Dear Review Panel,

I am submitting my below comments with regards to CN's submission Package 8, #705, dated December 18, 2018.

SITE PLAN + STATISTICS

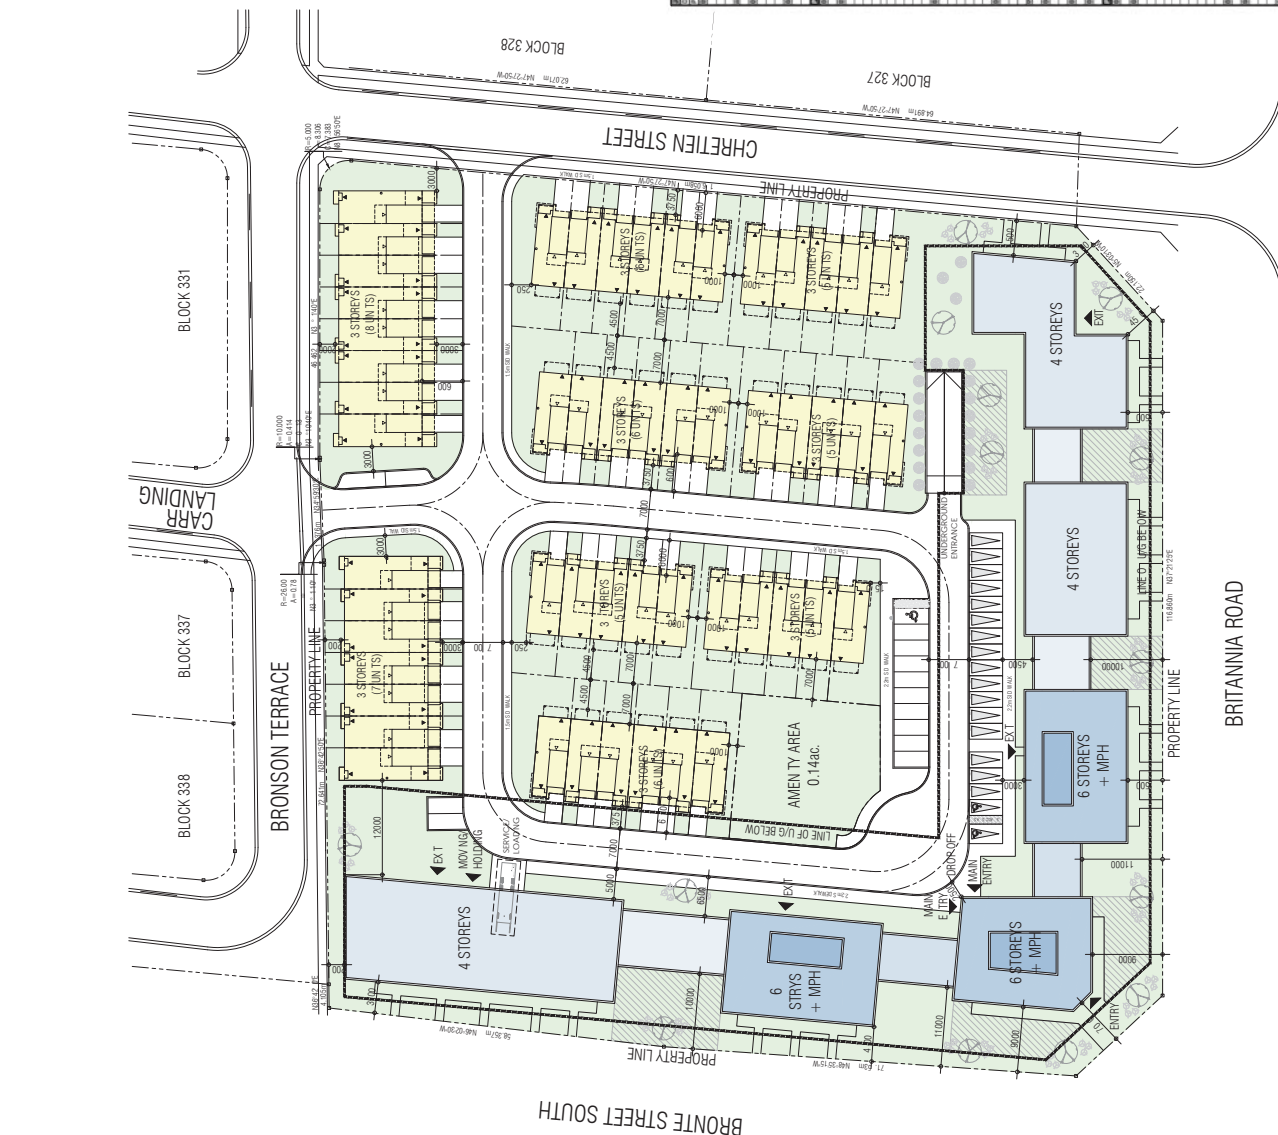
The second issue is that there is an application with the Town of Milton that six (6) mid-rise residential buildings are being proposed at the northeast corner of Britannia Road and Bronte Street South. These buildings are between 4 and 6 storey high. See the attached site plans which are also available from the Town's website. As these buildings are going to be built on higher ground elevations, they would also have direct line-of-sight to the CN operations.

- Elevation differences between the site and receptors to the north of the site, along Bronte Street South and CN railway tracks; and
- The new development at the northeast corner of Britannia Road and Bronte Street South.
